A
TRANSNUCLEAR
AN AREVA COMPANY

April 20, 2010
E-29128

Subject: Revision 2 to Transnuclear, Inc. (TN) Application for Revision 3 to Certificate of Compliance No. 9302 for the Model No. NUHOMS®-MP197 Packaging – Response to Request for Additional Information (Docket No. 71-9302, TAC No. L24336)

Figure 7-3.1

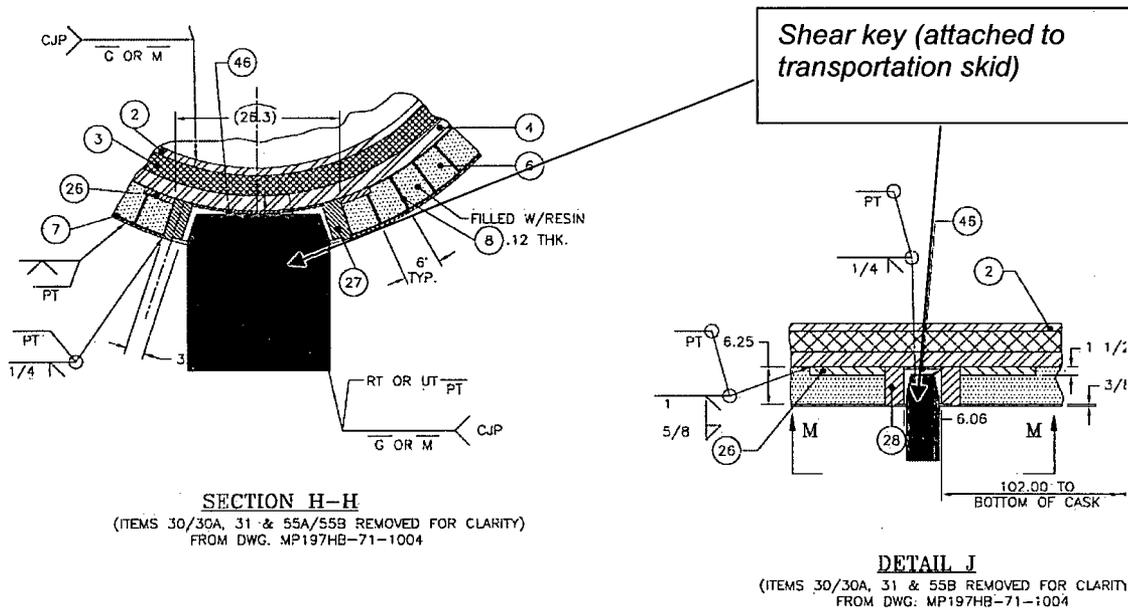
The shear key plug is not installed before the cask is placed in a horizontal position and secured on the platform (e.g., before transport), and is not used during transport, because of the presence of the transport skid shear key, which serves to resist the longitudinal accelerations of the cask during transport.

To be more specific, in the transport configuration, the shear key, which is part of the transport skid, fills the space shown on section H-H and detail J of SAR drawing MP197HB-71-1005 sheet 1 (please see Figure 7-3.1 below).

The shear key plug is only installed after the cask has been lifted from the skid and upended/rotated to a vertical position. Its purpose is to provide neutron shielding in the void that was previously filled by the shear key during transport.

SAR Chapter A.1, Appendix A.1.4.10 drawing MP197HB-71-1002 is revised to specify the same material as the rest of the cask neutron shield (Vyal B, item 6) for the shear key plug material (item 31). Therefore, a requirement for examining the shear key plug material to ensure that the plug is made with the same neutron shielding material as that on the cask side is unnecessary.
